Product Change Notification / SYST-25QUDS815

ERRATA - PIC32MZ Embedded Connectivity with Floating Point Unit (EF) Family Silicon Errata

PIC32MZ Embedded Connectivity with Floating Point Unit (EF) Family Silicon Errata and Data Sheet Clarification

FIGURE 1: Posc CRYSTAL CIRCUIT

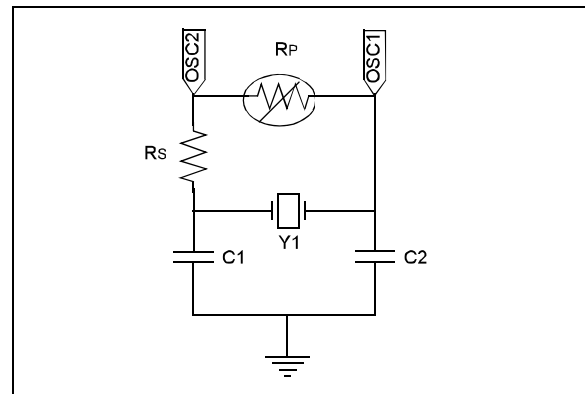
Revision A1 Silicon: A crystal oscillator cannot be used as an input to the Primary Oscillator (Posc) pins OSC1 and OSC2.

Revision A3 and B2 Silicon: The Posc has been tested in a normal power-up sequence and supports specific crystal operation.

The Primary Oscillator (Posc) has been characterized to operate at 8 MHz, 12 MHz, and 24 MHz when the circuit in [Figure 1](#) is implemented, and the operating conditions listed in [Table 3](#) are met.

Silicon Work around 1

Note 1: Using any other crystal frequency will require special component selection and characterization.

2: A parallel resistor (Rp) should not be used to increase the gain of the POSC.

64-PIN QFN⁽⁴⁾ AND TQFP (TOP VIEW)

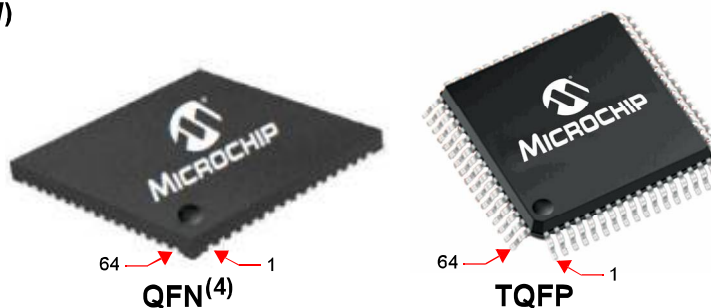
In Table 2, “Pin Names for 64-pin QFN and TQFP Devices” of the current data sheet, the AECRS_{DV} signal was erroneously omitted from the pin number 44 and added to the pin number 62. The correct assignment is shown in bold type in the following table.
